October 05, 2011

Notification of Proposed Modification - Doris North Water Licence 2AM-DOH0713 Part H Item 1 (Airstrip Expansion and Bypass Road Design)

Appendix A: Engineering Drawings

Airstrip Expansion - Plan

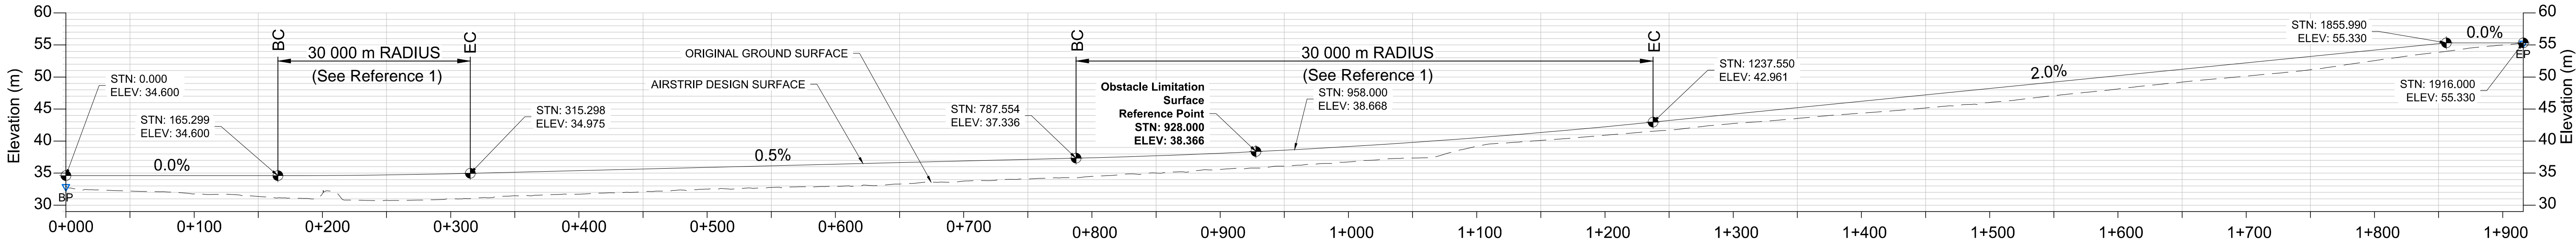
HBML hereby submits notice of its proposal to revise the design of the airstrip expansion at the existing airstrip location. The original design included a separate bypass road constructed on the east side of the expanded airstrip. HBML has decided to remove the separate bypass road and include an 8-m wide attached bypass road that is constructed along the east edge of the expanded airstrip. The redesigned airstrip expansion is illustrated in the drawings attached to this letter at Appendix A.

The original design of a separated bypass road was intended to allow continued traffic flow during aircraft activities, and to eliminate vehicle traffic from the airstrip. However, HBML's aircraft service provider has indicated that vehicle traffic may not be present on the bypass road during aircraft take-off or landing. For this reason, the original bypass road and airstrip has been redesigned to reduce the activity footprint, while still allowing HBML to keep vehicle traffic off of the airstrip.
